UNITED STATES PATENT AND TRADEMARK OFFICE

Office Action Summary

10/042,057

BALDAUF ET AL.

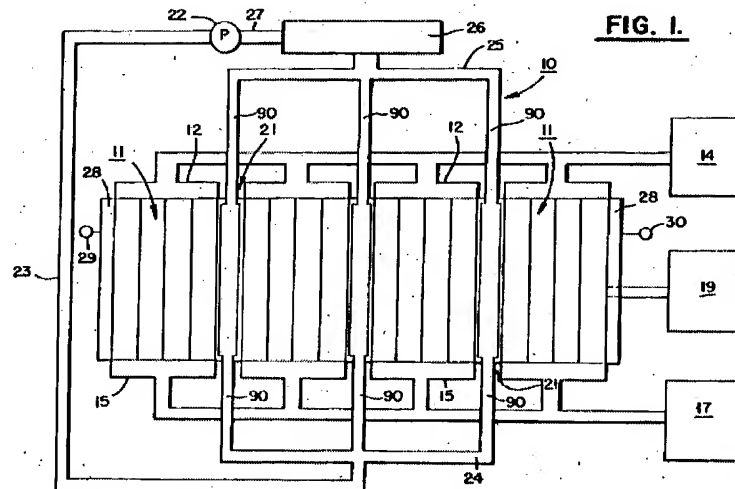
Claim 6 is rejected under 35 U.S.C. 103(a) as being unpatentable over Einhart et al. U.S. Patent 6,531,876 in view of Wittel U.S. Patent 4,583,583.

The reference is silent to at least two of the subsystems having respective cooling circuits, configured to be connected by series or parallel.

However, Wittel teaches that it is conventional to employ subsystems having respective cooling circuits in series/parallel as illustrated in Figure 1:

in order to maximize heat transfer from the fuel cell stack to the coolant without undue manufacturing and assembly tolerances and to avoid shunt currents without the need for additional electrical isolation form adjacent cells of the fuel cell stack. See column 3, lines 5-25.

Therefore, it would have been obvious to one of ordinary skill in the art at the time the instant invention was made to employ the cooling circuits of Wittel in the fuel cell stack of Einhart, in order to maximize heat transfer from the fuel cell stack to the coolant without undue manufacturing and assembly tolerances and to avoid shunt currents without the need for additional electrical isolation form adjacent cells of the fuel cell stack.

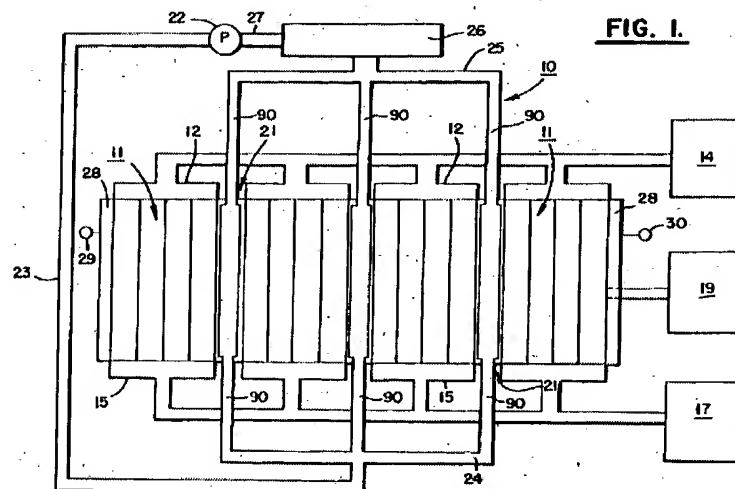
Claim 6 is rejected under 35 U.S.C. 103(a) as being unpatentable over Barton et al. U.S. Patent 6,724,194 in view of Wittel U.S. Patent 4,583,583.

The reference is silent to at least two of the subsystems having respective cooling circuits, configured to be connected by series or parallel.

However, Wittel teaches that it is conventional to employ subsystems having respective cooling circuits in series/parallel illustrated as in Figure 1:

in order to maximize heat transfer from the fuel cell stack to the coolant without undue manufacturing and assembly tolerances and to avoid shunt currents without the need for additional electrical isolation form adjacent cells of the fuel cell stack. See column 3, lines 5-25.

Therefore, it would have been obvious to one of ordinary skill in the art at the time the instant invention was made to employ the cooling circuits of Wittel in the fuel cell stack of Barton, in order to maximize heat transfer from the fuel cell stack to the coolant without undue manufacturing and assembly tolerances and to avoid shunt currents without the need for additional electrical isolation form adjacent cells of the fuel cell stack.
